US COMMISSION OF FINE ARTS PRESENTATION | JULY 18, 2019

World War One Memorial

Response to Sculpture and Lighting Comments + Site Security and Final Detailing

SIMPLIFIED PLINTH WITHOUT CANTILEVER

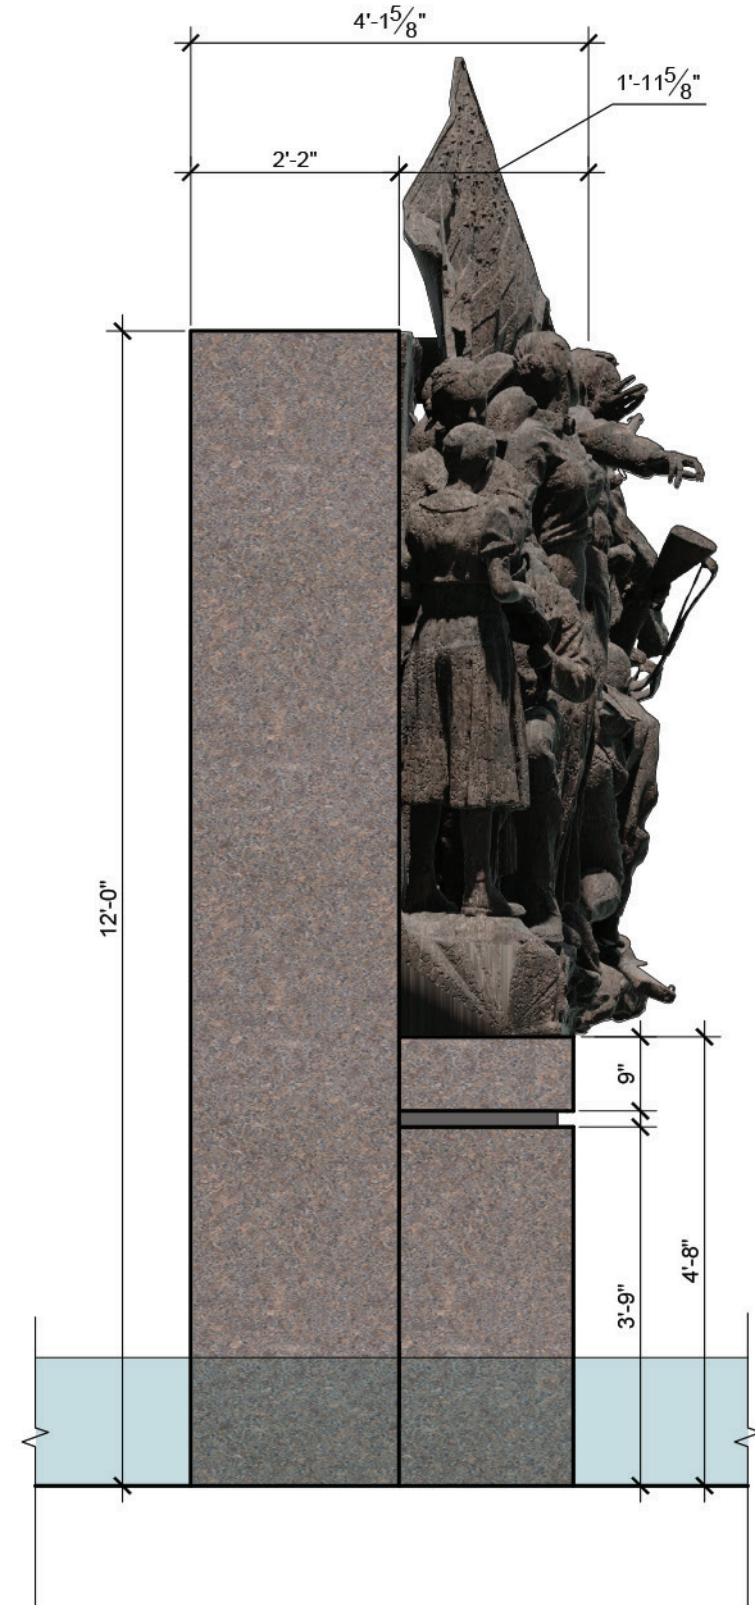
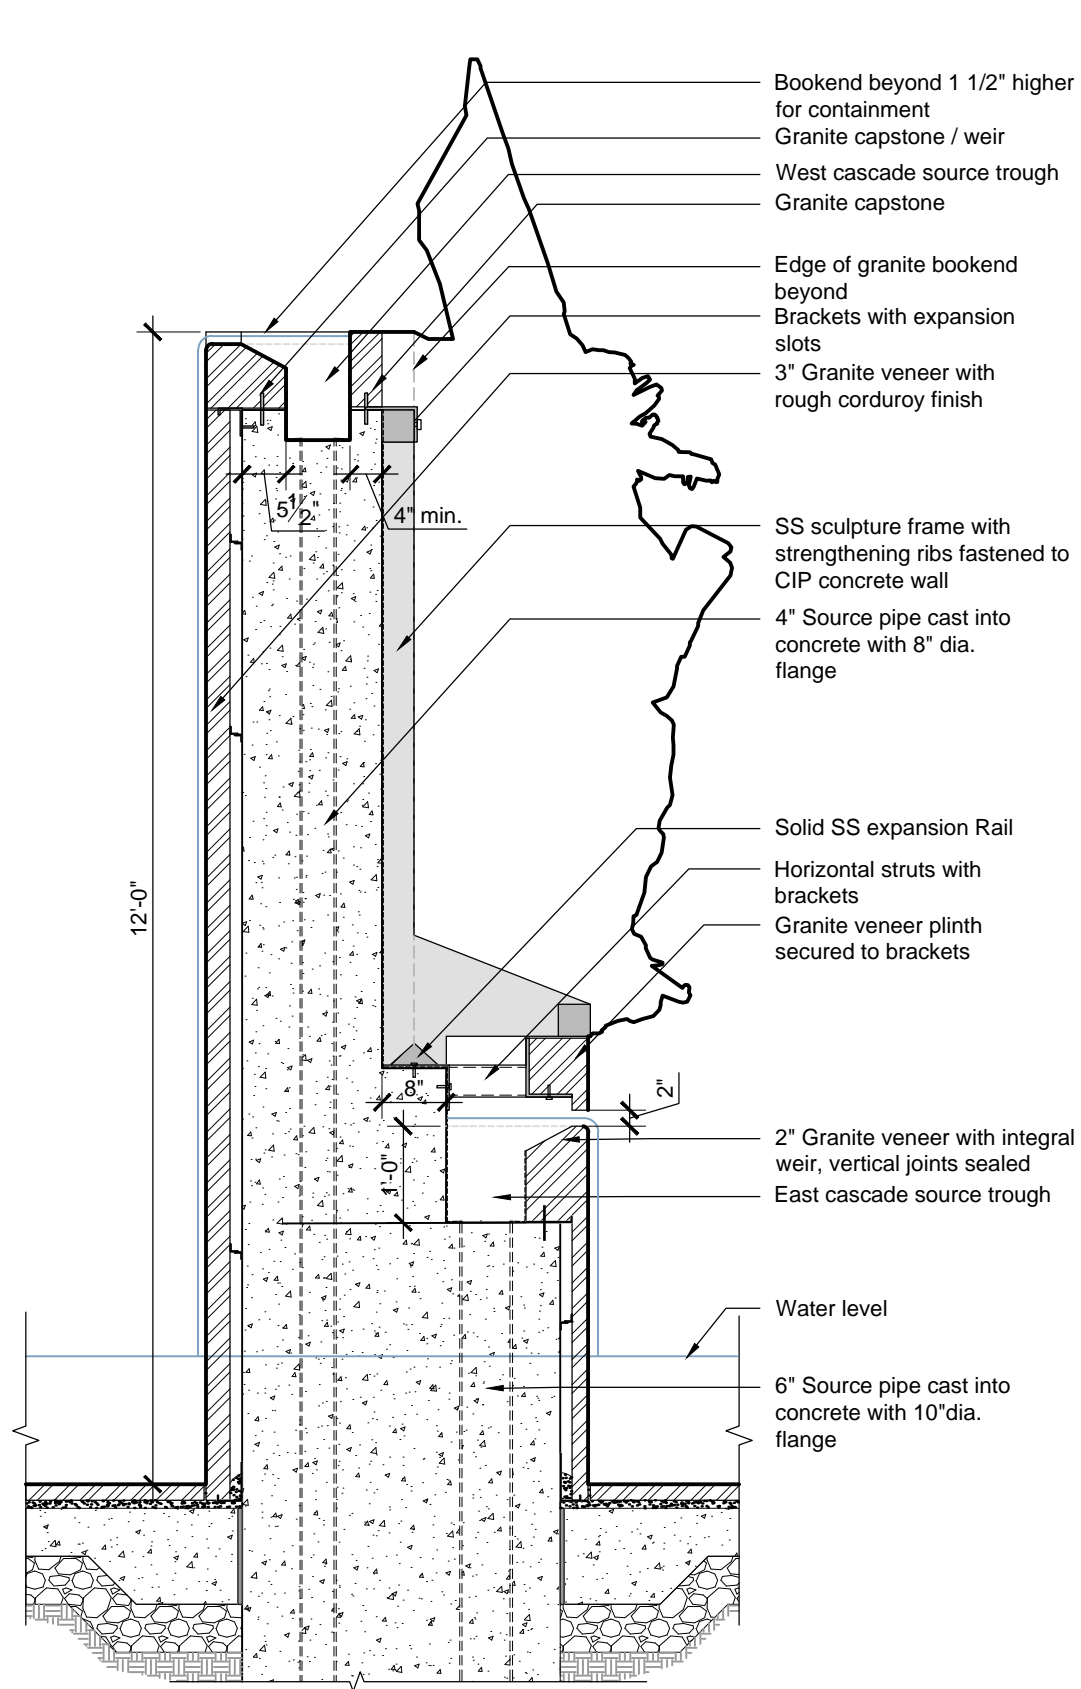
Directives and Responses (April 2019 CFA)

- Raised concern that the base remains unresolved and does not successfully integrate the bronze sculpture with the stone wall
- Studied extending the stone bookends behind the sculpture back to better integrate the two and allowing the bronze to sit proud at the base to create a shadow line (all options)

- Citing the simple monolithic quality of the existing granite walls at the Pershing Memorial, recommend eliminating the stone shelf with vaguely classical detailing immediately below the sculpture to simplify the number of design elements into a coherent relationship between only two

- Studied the removal of the classical detailing (all options) and of the stone shelf (option 1 only)
- Recommended that the best solution would likely have the water cascading directly below the base of the bronze sculpture rather than being set off by an intermediary stone base (shelf) beneath the sculpture

Response

- Plinth remains to provide separation of east cascade to sculpture to deter bronze disease
- Classical detailing is removed
- Cantilever is removed allowing the stone support to read as one element rather than multiple when the cascade is off
- Sculpture sits proud of the stone support and bookends
- Monolithic quality is maintained while the east cascade is on and while off

EXISTING FIXTURES

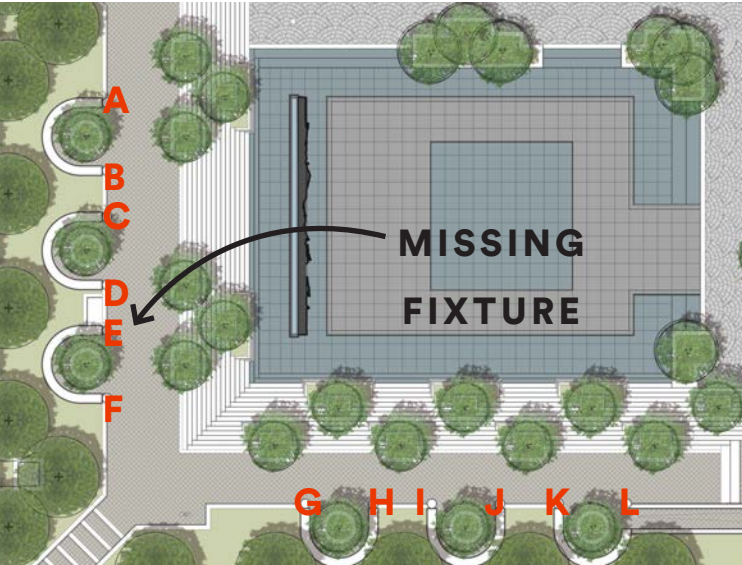
- Questioned the removal of the 12 historic multi-globe fixtures along the upper walkway, emphasizing their important role in the shaping of a coherent spatial experience
- Questioned whether the glare produced by the historic fixtures would be more problematic than the glare from adjacent fixtures outside of the park
- **Determined that while glare outside of the park boundary is unavoidable, it is preferable to adjust the fixtures that we can control to best accommodate a successful memorial experience**

PADC Light Fixture

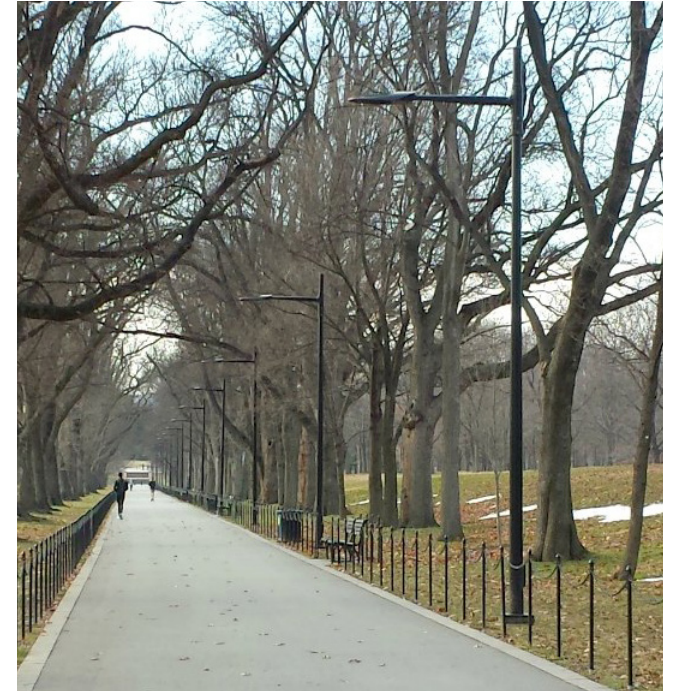
- Questioned the removal of the 12 historic multi-globe fixtures along the upper walkway, emphasizing their important role in the shaping of a coherent spatial experience
- Concluded that using a single fixture type for multiple conditions compromises the geometric structure and spatial clarity of the plan, particularly along the upper walkway
- Replace the existing multi-globe fixtures with the PADC double headed fixture from PA Ave and the Grove

NE CORNER - CONTINUATION OF PA AVE PLANTER BENCHES

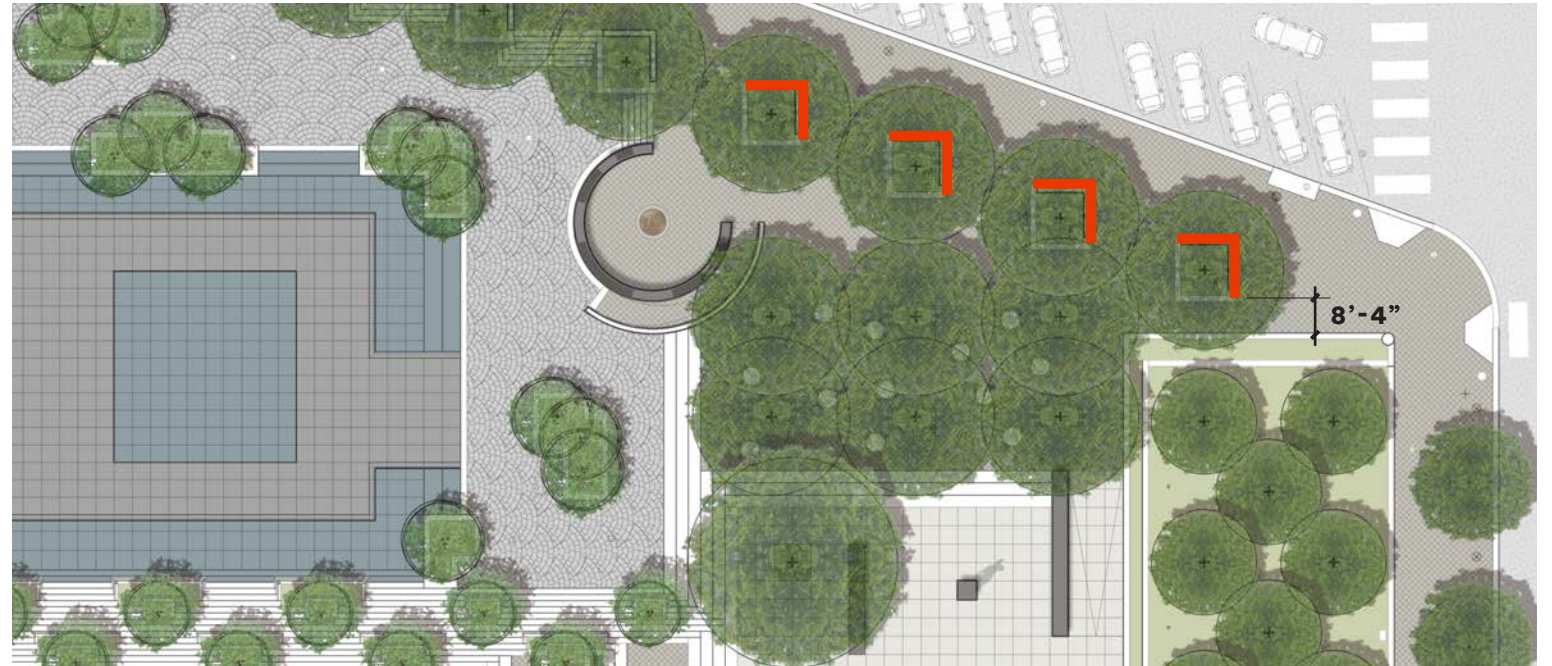
- Continuation of the existing PA Avenue benches and planters
- Chevron form adds strength and can be designed with a deep footer to deter vehicles
- Works from a security standpoint to protect the grove from errant vehicles
- In character with the existing park
- Means of differentiating new planters requested by SHPO at June 11th meeting; stone texture has been roughened to accommodate this request

TENTATIVE CAMERA LAYOUT

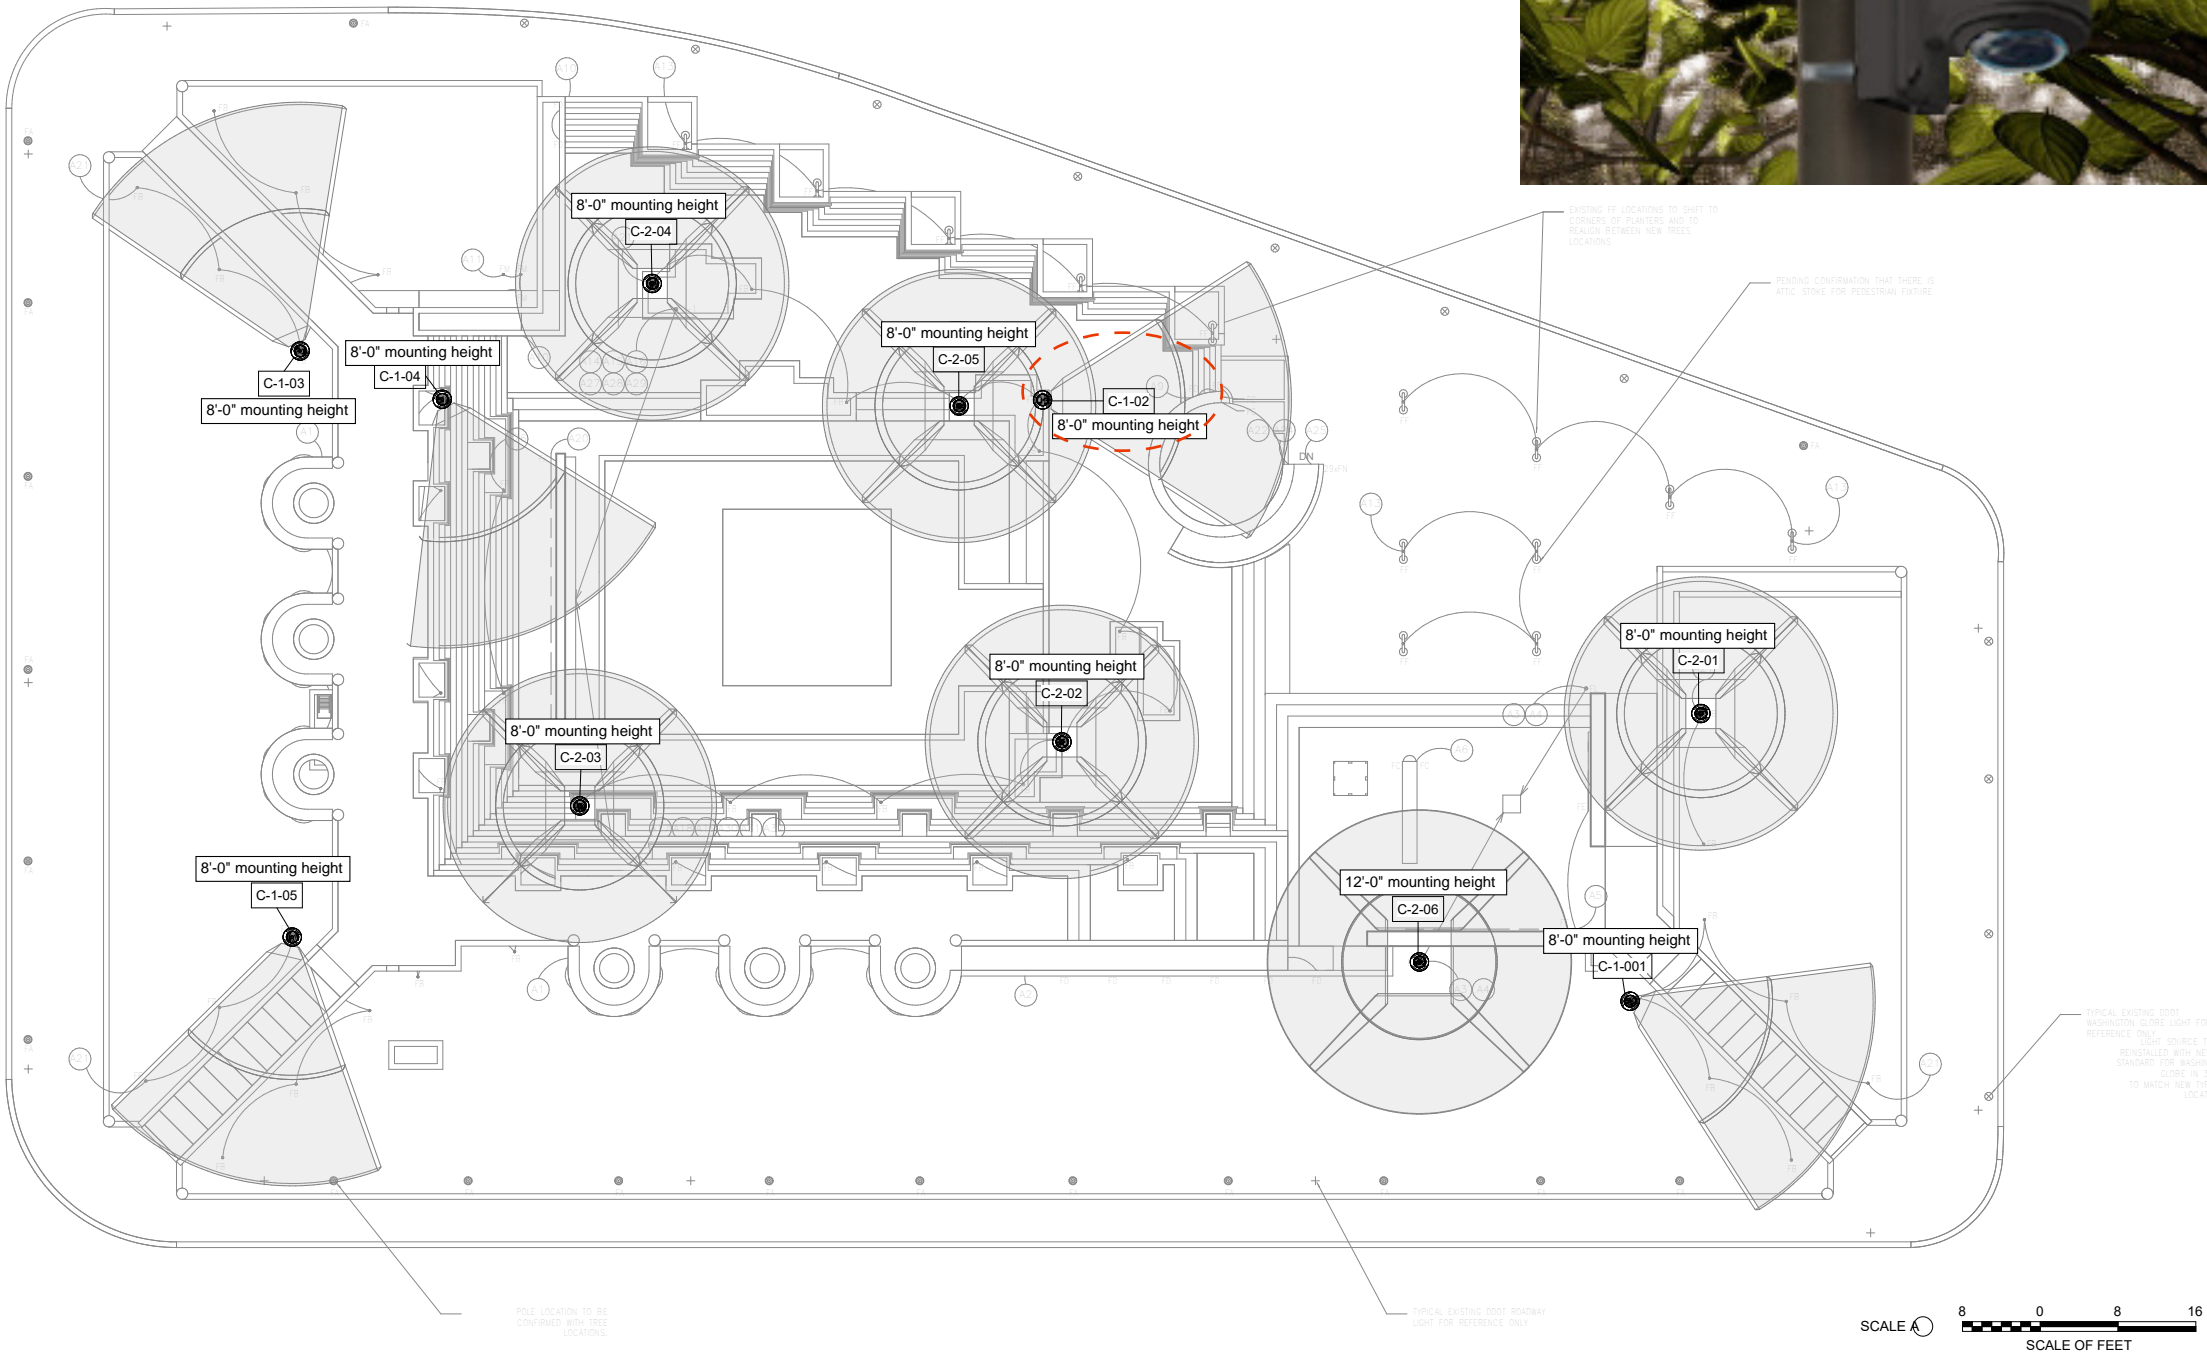
- Cameras to be located on existing light poles
- USPP have requested 11 cameras within the park for optimal surveillance

FREESTANDING IN GROVE

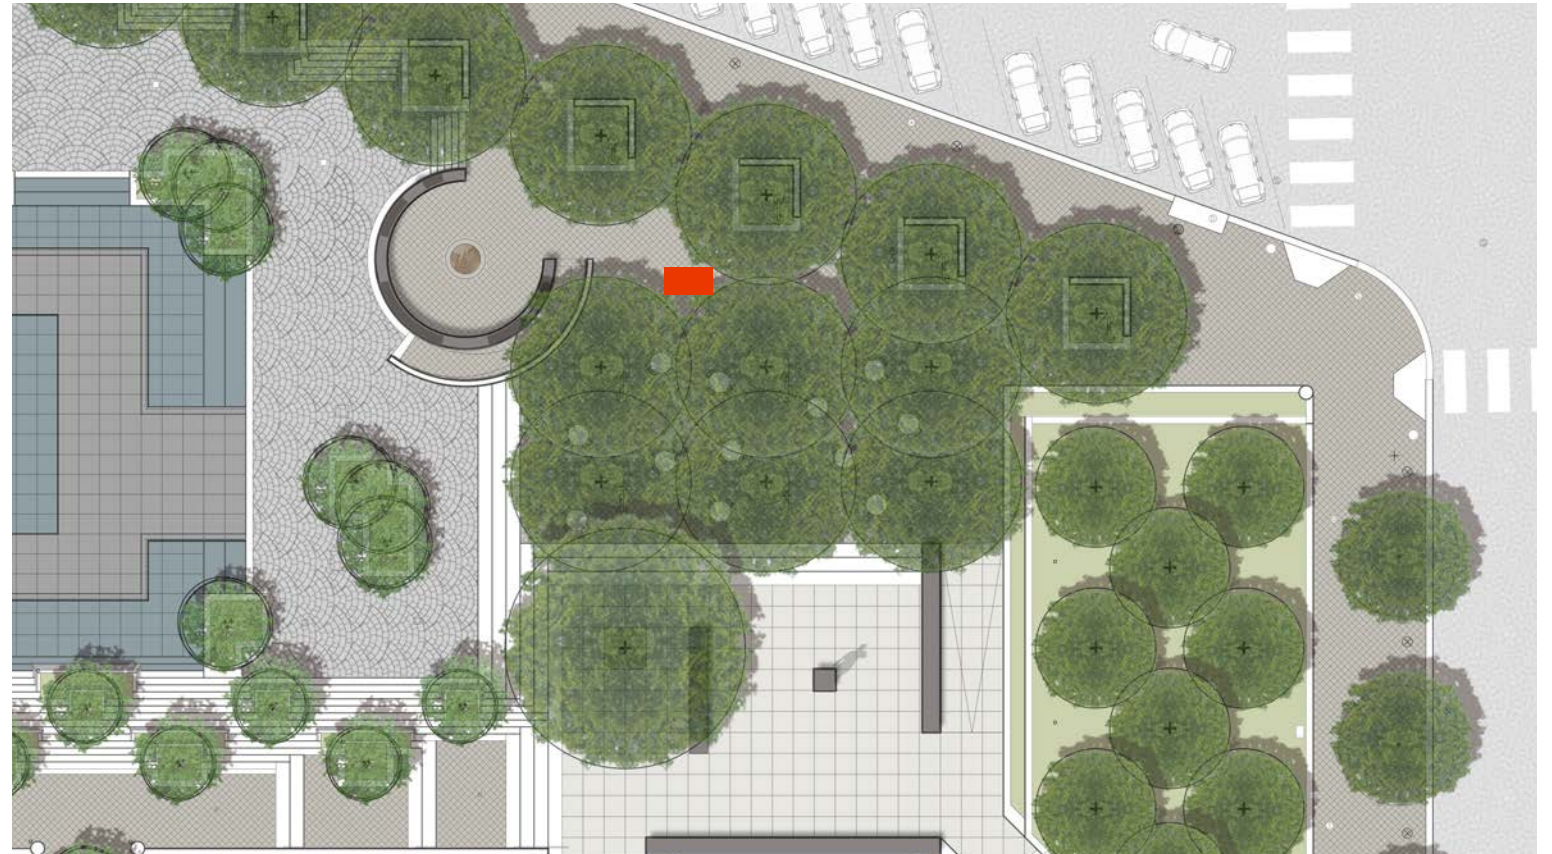
- Grove location approved by CFA during April 2019 presentation
- Detailing inspired by Pershing and Belvedere walls
- Carnelian honed granite with bronze scale model aligned in the same orientation as the park

PARSONS TABLE

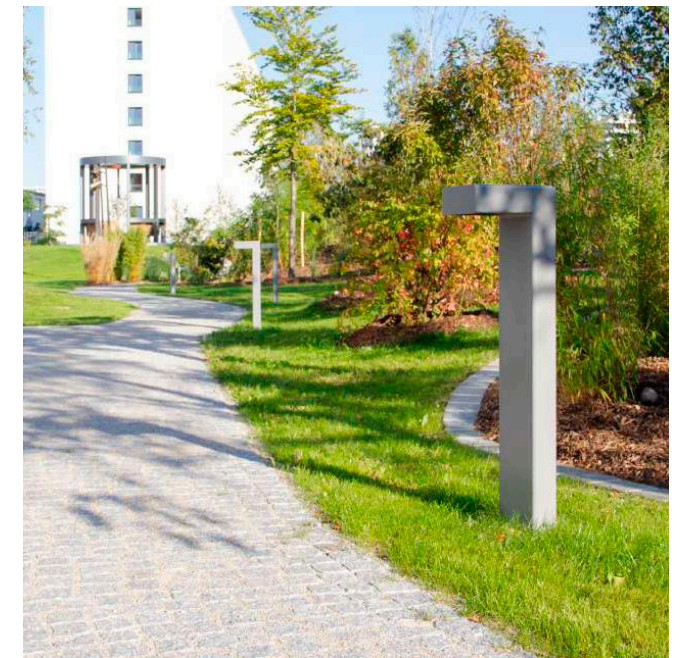
- Plinth remains to provide separation and allow the east cascade to remain without accelerating bronze disease
- Classical detailing is removed
- Stone support takes on a modernist “Parsons Table” style with square bookends at the cascade below the plinth

Hess Linea Bollard

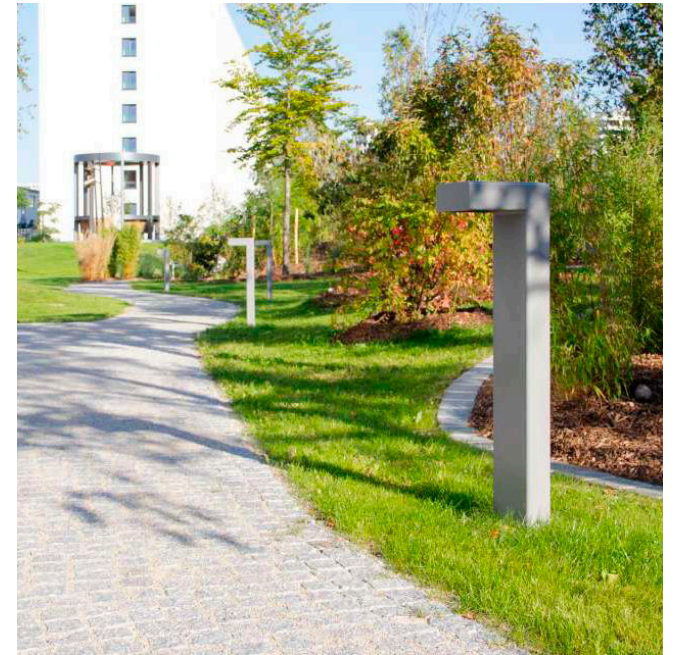
- Questioned the removal of the 12 historic multi-globe fixtures along the upper walkway, emphasizing their important role in the shaping of a coherent spatial experience
- Concluded that using a single fixture type for multiple conditions compromises the geometric structure and spatial clarity of the plan, particularly along the upper walkway
- Studied the use of a dimmable fixture that could be field adjusted to a reduced wattage to minimize impacts on the memorial experience at night
- Additional pathway lights and tree uplights required to meet the minimum lighting levels and design goals
